## Urgent: Field Safety Notice

Fisher & Paykel Healthcare Airvo™ 3

**F&P Reference: FA-2024-003**

Fisher & Paykel Healthcare (F&P) is initiating a field safety corrective action to update Airvo 3 devices that have software version v1.5.1 or earlier installed.

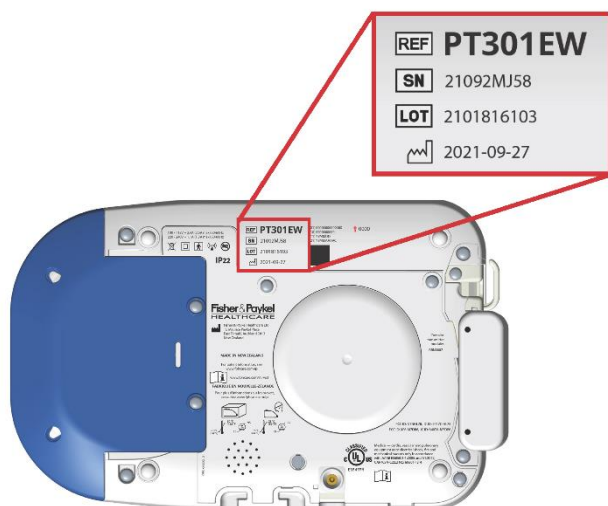
This field safety corrective action relates to specific versions of software of the Airvo 3, and how the device responds when flow alignment alarm 3.2.2 occurs.

When this happens in Airvo 3 devices set up with High Pressure Oxygen (HPO) and running software version 1.5.1 or earlier, the device will deliver room air only. If this happens, a patient may experience oxygen desaturation that could lead to hypoxia.

Software version 1.5.2 updates the software algorithm and ensures the target therapy continues in the event that this alarm occurs.
